HISTORIC AND DESIGN REVIEW COMMISSION

June 05, 2019

HDRC CASE NO: 2019-315
ADDRESS: 310 CALLAGHAN AVE
LEGAL DESCRIPTION: NCB 721 BLK 3 LOT N 80.04 FT OF 3
ZONING: RM-4
CITY COUNCIL DIST.: 1
DISTRICT: Lavaca Historic District
APPLICANT: Justin Ferdinand/Alamo Wealth Builders, LLC.
OWNER: Justin Ferdinand/Alamo Wealth Builders, LLC.
TYPE OF WORK: Exterior modifications
APPLICATION RECEIVED: May 17, 2019
60-DAY REVIEW: July 16, 2019
CASE MANAGER: Huy Pham

1 SOUTH ELEVATION
Scale: 3/16" = 1'-0"
0 1 5 10
GRAPHIC SCALE

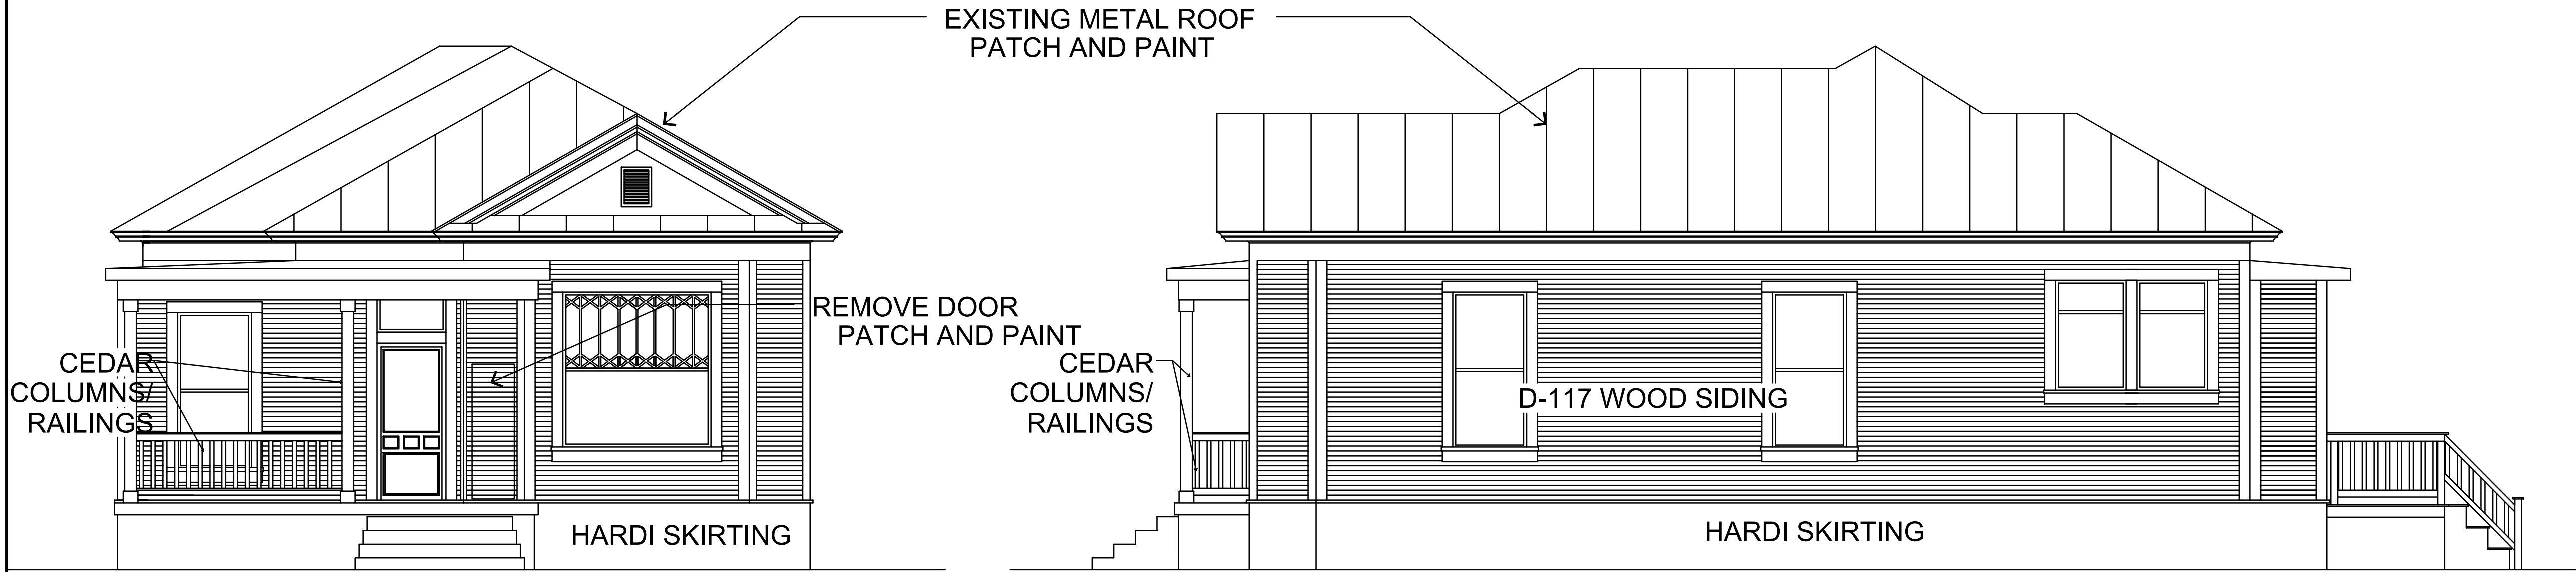
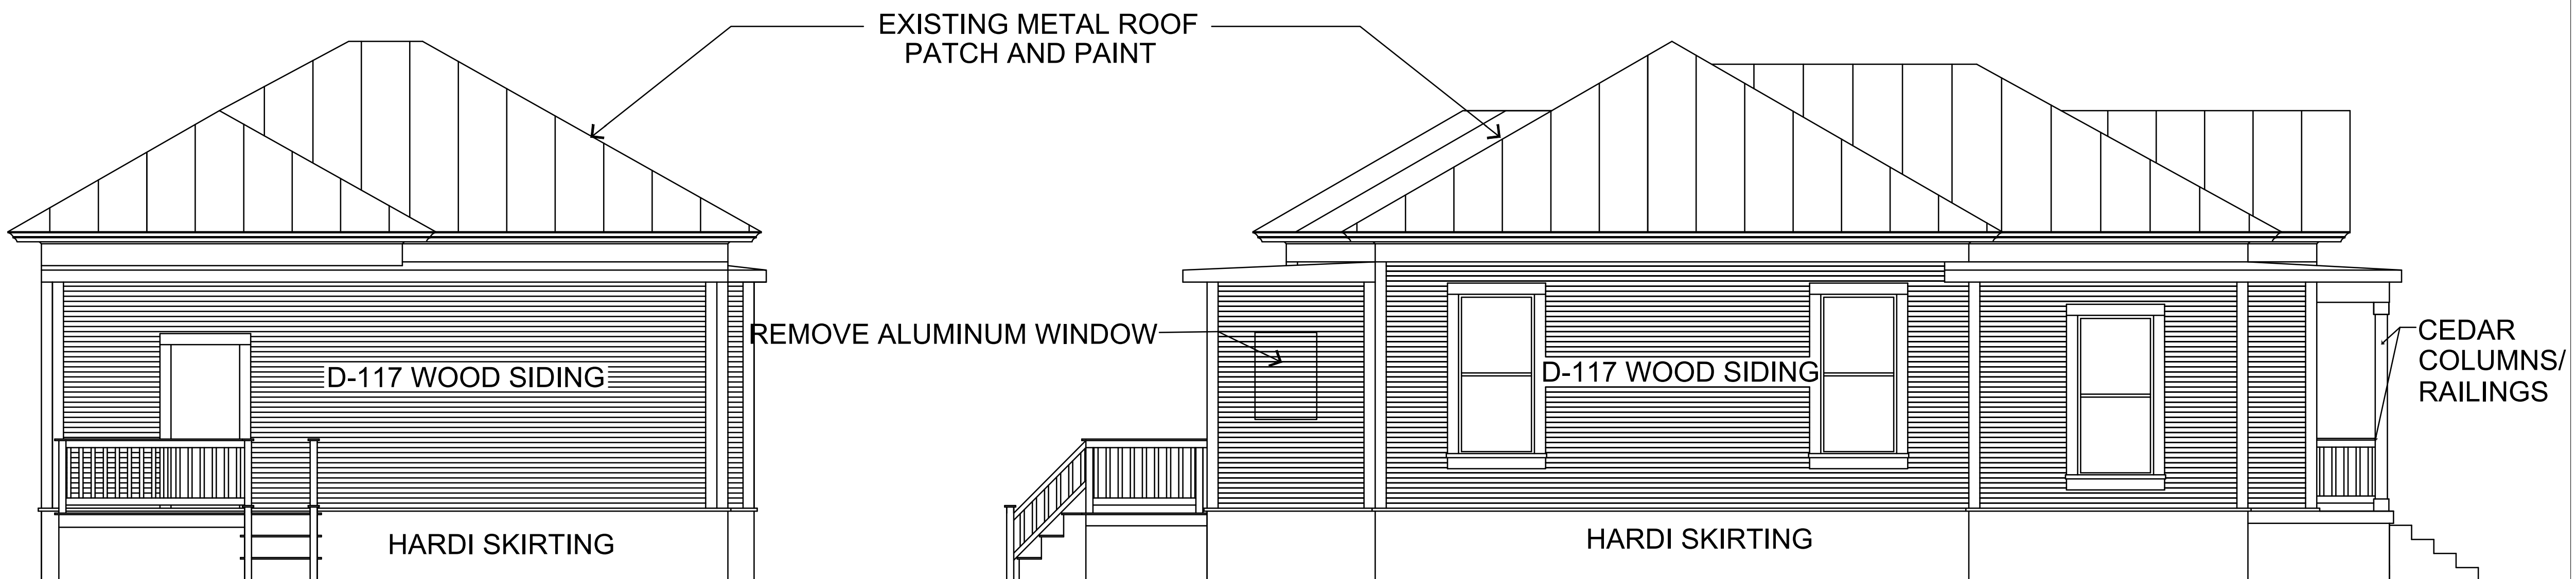
Request Item	Staff Notes	Action needed by applicant
Close off rear door and repair with new d117 siding to match existing	Requires HDRC hearing	rear elevation drawing, additional photos (see A2.0/3 & Image A, E)
Demo patio cover over existing rear door	May be eligible for admin, need to verify non-original status	additional photos (see Image A)
Remove kitchen window to rear to backyard and replace with front door	Requires HDRC hearing	rear elevation drawing, additional photos (see A2.0/3 & Image B)
install front wood door w new patio deck	Requires HDRC hearing	rear elevation drawing, additional photos (see A2.0/3 & Image B)
Restore 8 wood windows and install new wood screens	Requires HDRC hearing	Profile photo of each window, specifications for proposed windows, window schedule (see A2.0/1, 2, 3,4 & Image C)
install electric or solar gate with metal and or horizontal cedar	Requires HDRC hearing	Site plan with proposed fence line, elevation drawing or example photo of proposed fence (see A0.2/1 & Image D)

Remove bathroom window and close off with existing d117 siding	Requires HDRC hearing	Elevation drawing (see A2.0/4 & Image E,F)
Landscape front yard (NOT PROVIDED)	May be eligible for admin, need to maintain a majority of plant cover/lawn with no new hardscaping	Site plan with landscape elements
Concrete ribbon driveway with crushed gravel	May be eligible for admin if 10ft wide, pavers advised against	Site plan (see A0.2/1 & Image G)
and crushed gravel in backyard (NOT PROVIDED)	May be eligible for admin	Site plan
Remove metal railings to go back with cedar posts and handrails	May be eligible for admin, needs to match historic profile, can ask for staff specifications	Elevation drawing for proposed front porch (see A2.0/1 & Image H)
remove vinyl/aluminum siding on entire house to expose existing D117 wood Siding	May be eligible for admin, need to verify scope	Photo of exposed wood siding under current vinyl siding, rotten wood should be replaced with matching profile (see A2.0/1,2,3,4 & Image E, I)

remove right front door and repair with existing D117 Siding	Requires HDRC hearing	Elevation drawing of front façade (see A2.0/1 & Image E, H)
remove vinyl siding and repair 3" overlap siding (Repeated)	May be eligible for admin, need to verify scope	Photo of exposed wood siding under current vinyl siding, rotten wood should be replaced with matching profile
move left door to the right 12" and replace w existing wood door	Requires HDRC hearing	Elevation drawing of front porch, drawing or example photo of proposed new door. If removing historic door, needs to match. (see A2.0/1 & Image J, K)
repair 6' fence to the right with horizontal cedar	May be eligible for admin if rear fence only	Site plan with fence line (see A0.2/1)
demo dilapidated stand alone carport demo shed on shared property	separate pending request by applicant Cameron Baker	
Continue fence build 8' ft fence on rear of property, 8' fence on rear dividing property lines would equate to 6' of privacy since house sits 2' above ground on pier and beam as permitted in city code, bringing enhanced value to the neighborhood to give proper privacy from neighbors.	Requires HDRC hearing, limit 6' in rear and 4' in front	Site plan with fence line (see A0.2/1 & Image L)
